ADDENDUM 01

Project Title: **Blinn Mechanical Project – Brenham – Melcher + BCPA Phase 2**
RSE Project #: **1540**

This **ADDENDUM** shall modify, amend, extend and become a part of the Contract Documents dated 1/13/25 prepared by Ramirez Simon Engineering, LLC (RSE) in accordance with the terms therein, as if written out in full therein and bound originally therewith.

P201

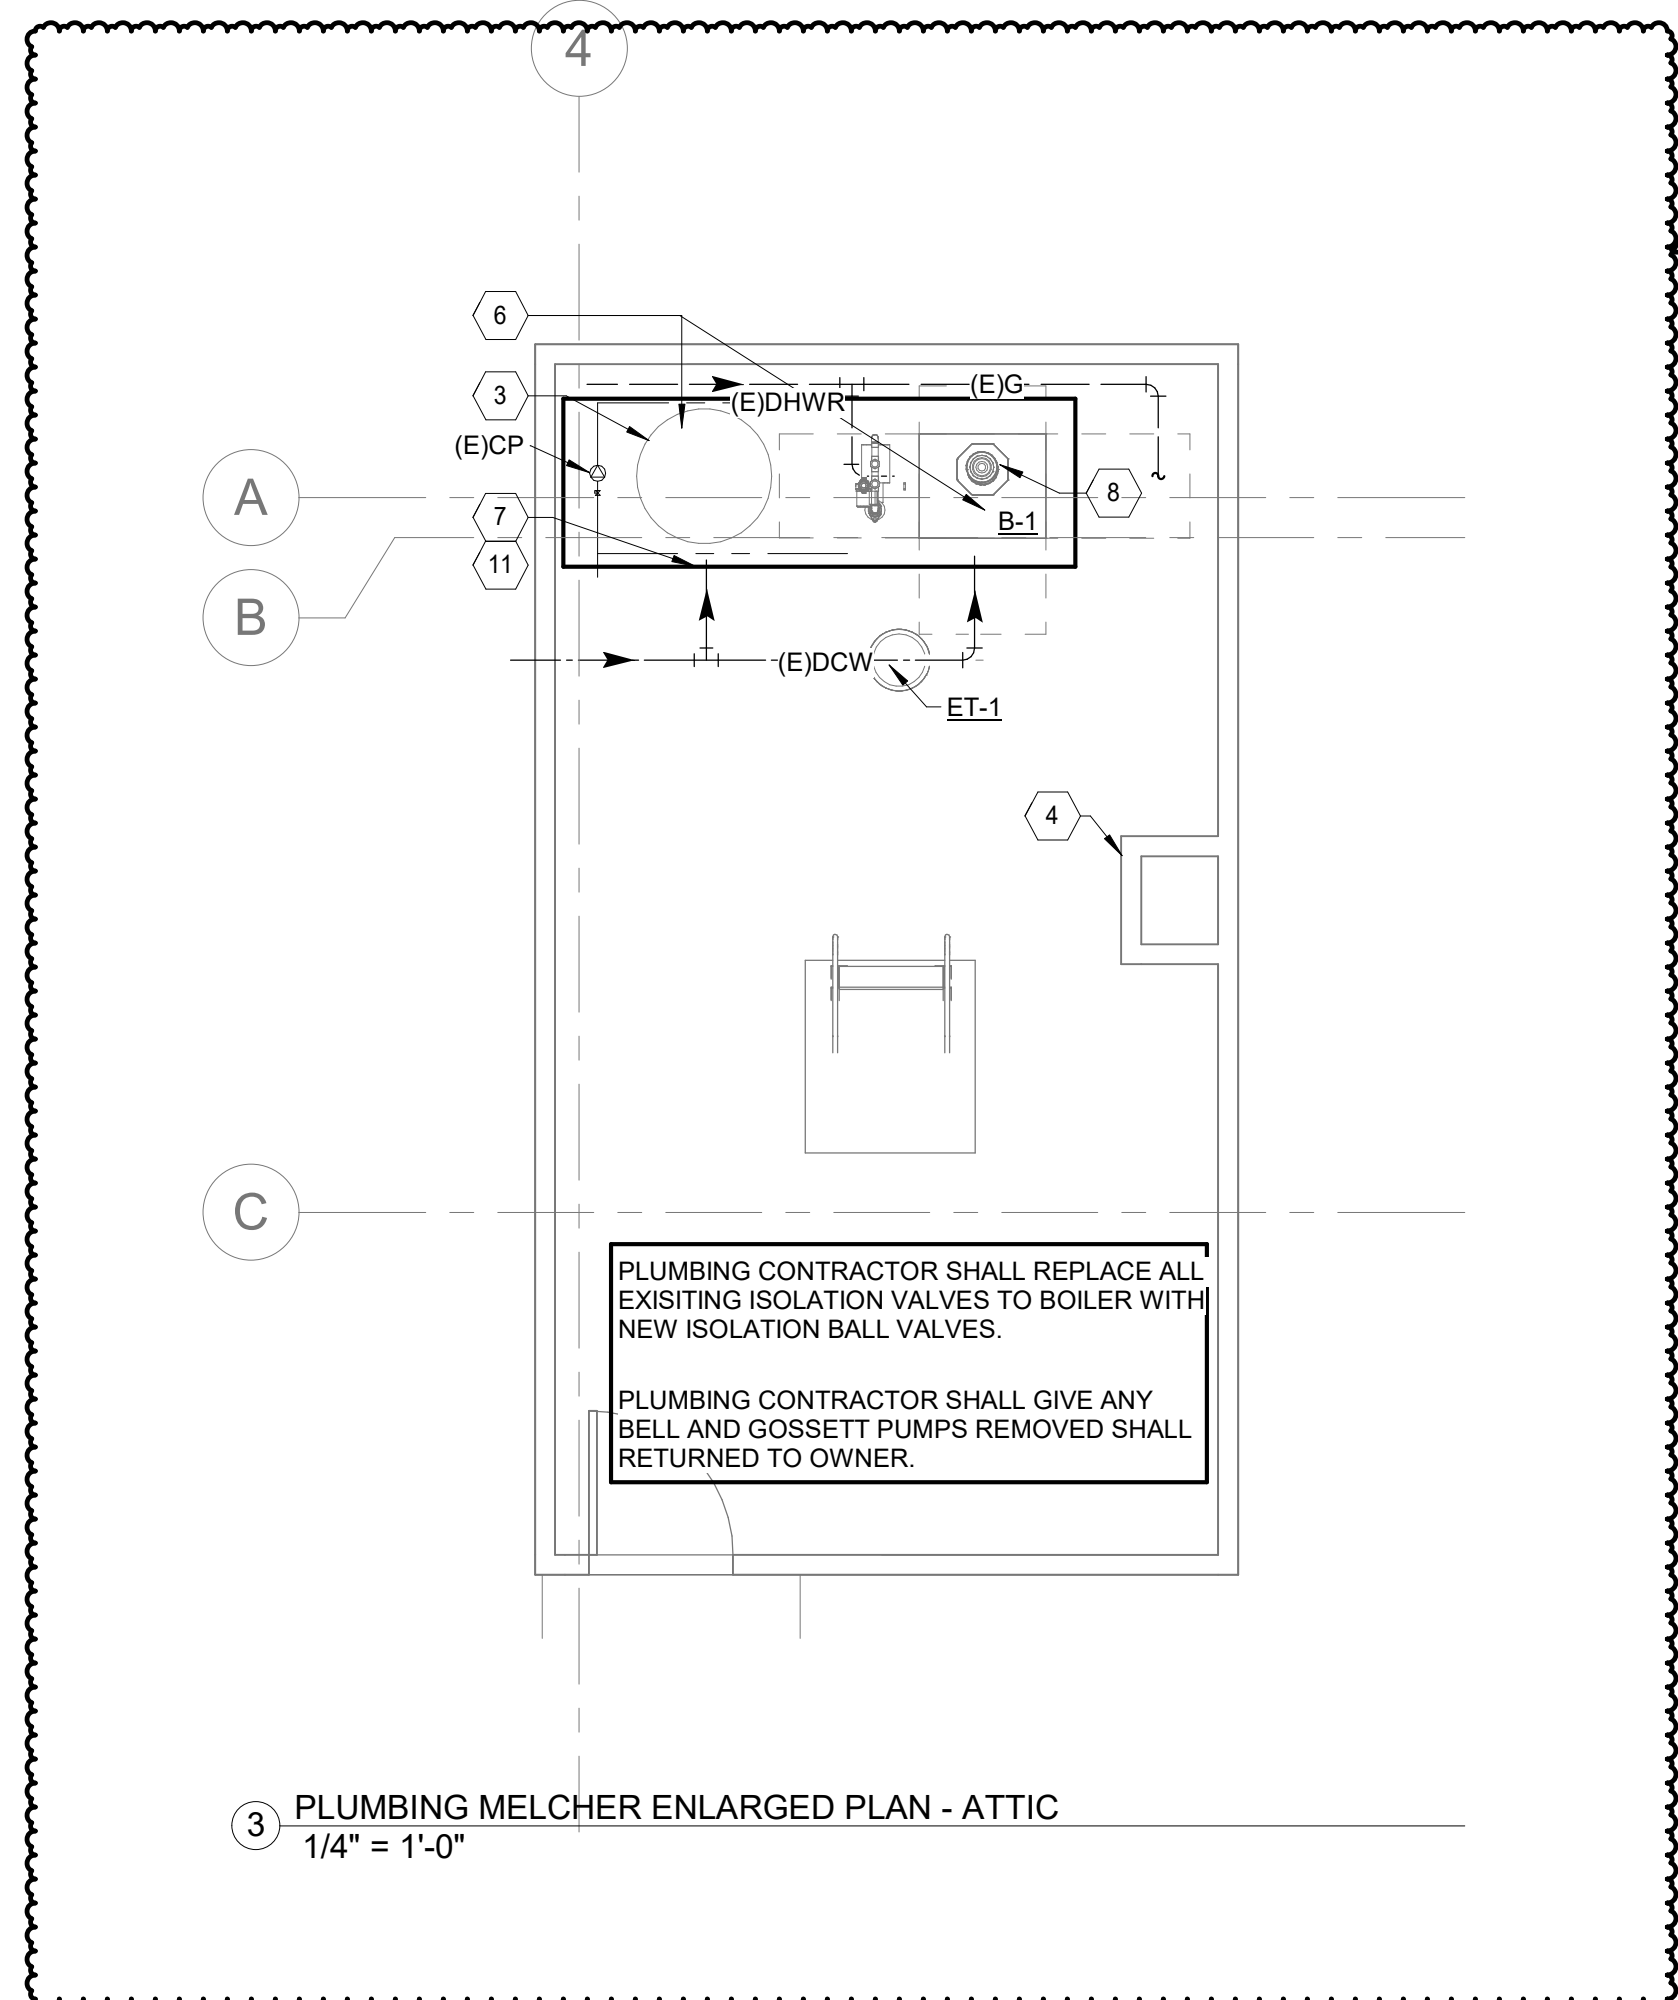
1. P201-PLUMBING MELCHER FLOOR PLANS
 - a. Updated Fixture Tag from B-3 to B-1 for new boiler.
 - b. Added notes to floor plan and to general note sections.

PLUMBING BCPA2 FLOOR PLAN

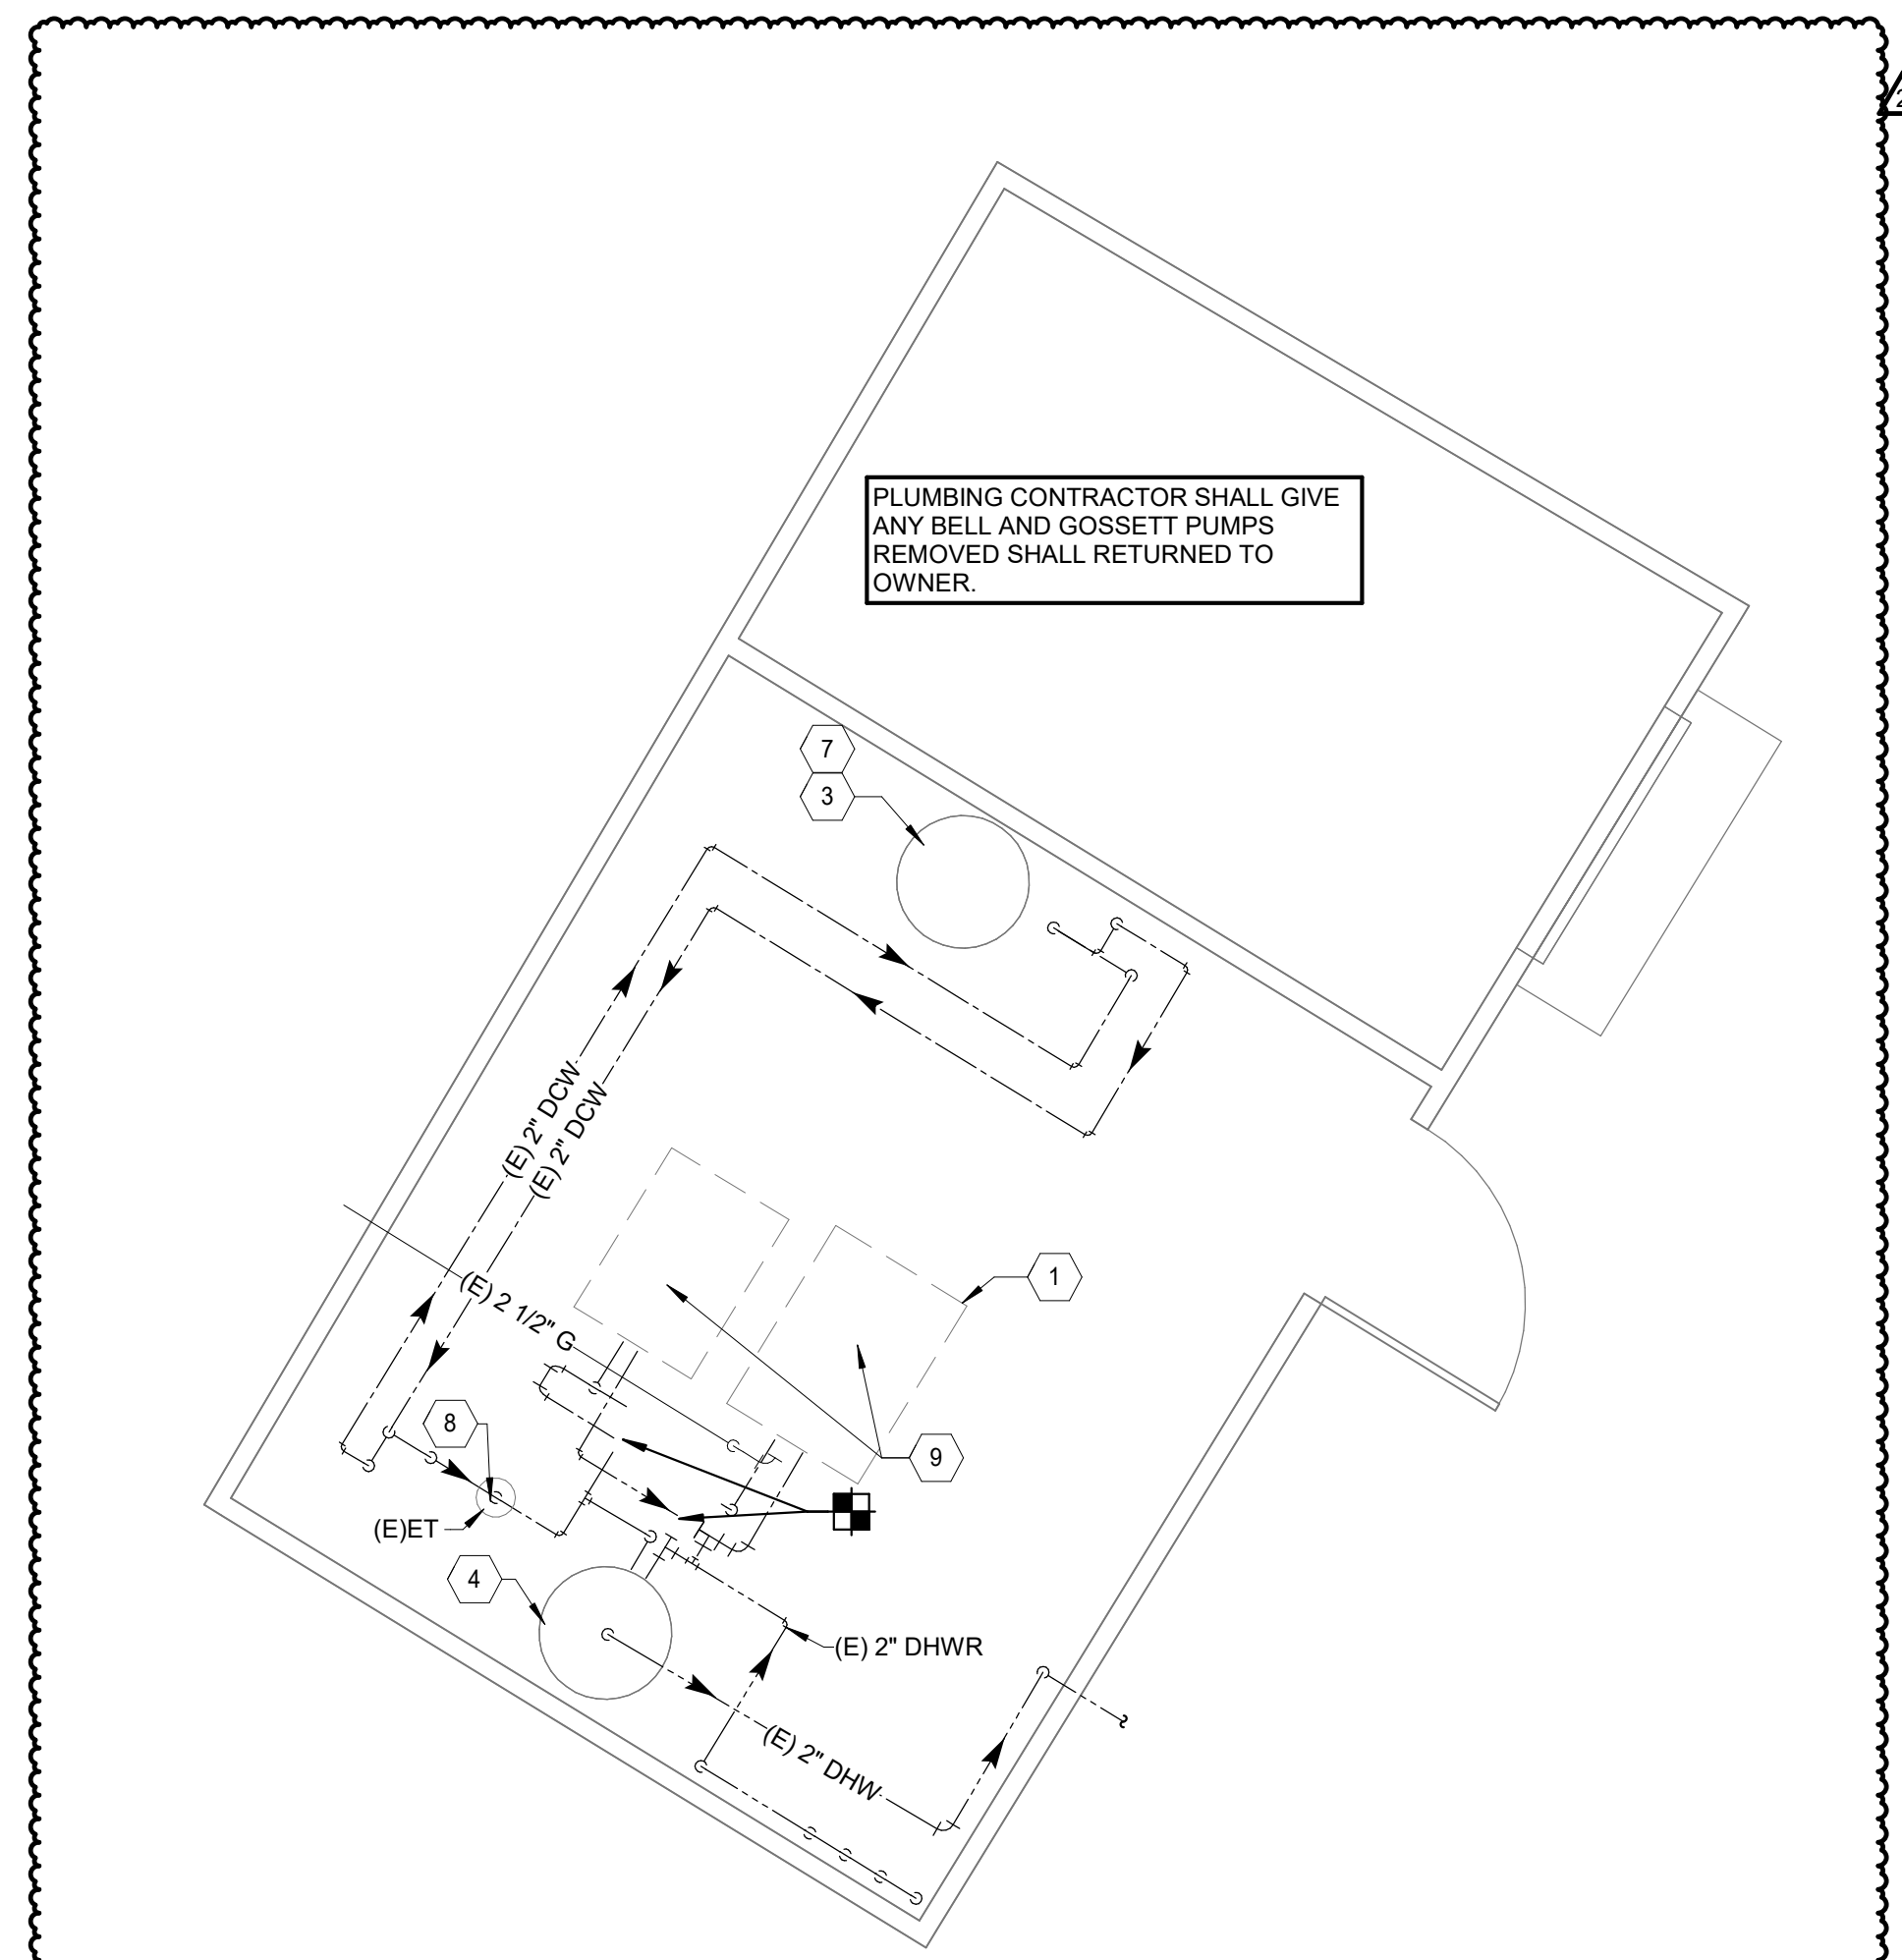
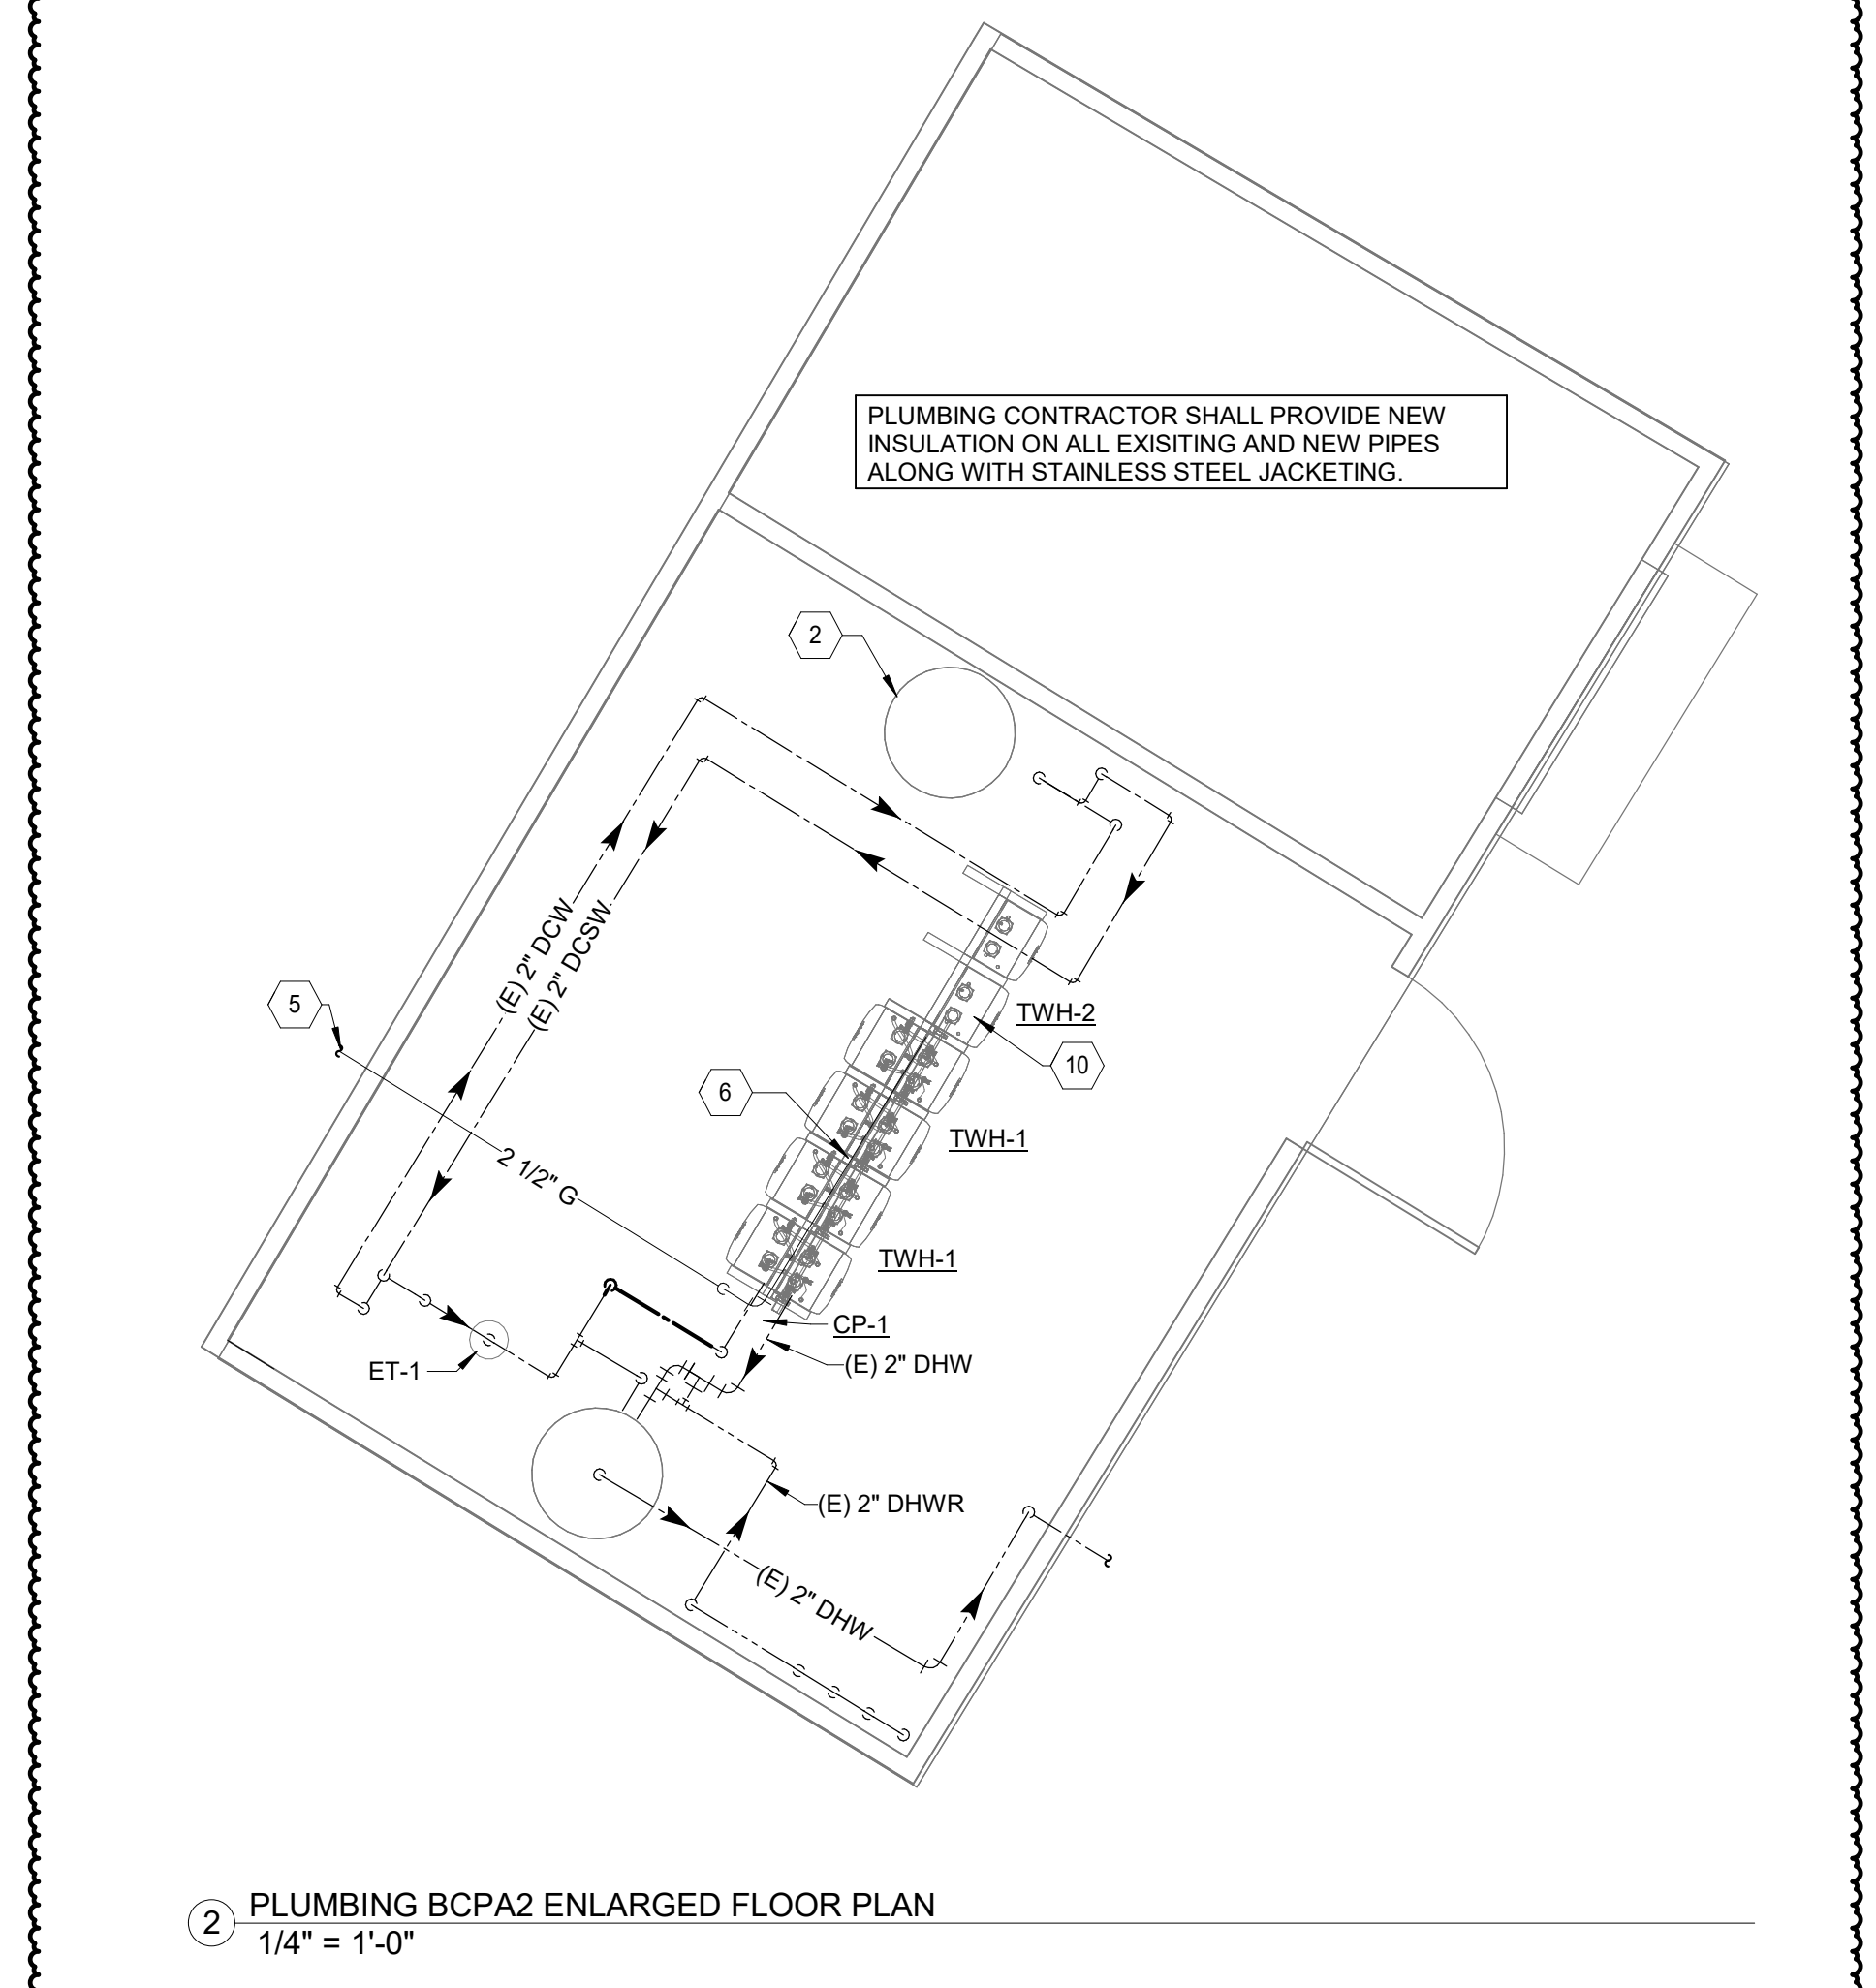
2. P202 – PLUMBING BCPA2 FLOOR PLAN
 - a. Updated number of tankless water heaters to 8 for base bid.
 - b. Added a alternate design to add a additional.
 - c. Updated piping on demo and new floor plans
 - d. Removed note referring to heat trace all pipes in area.
 - e. Added a note to remove insulation to softener.
 - f. Added note to demo existing expansion tank.
 - g. Added a note to remove existing flu back to roof penetration and abandon in place.
 - h. Added note to general note and to plans
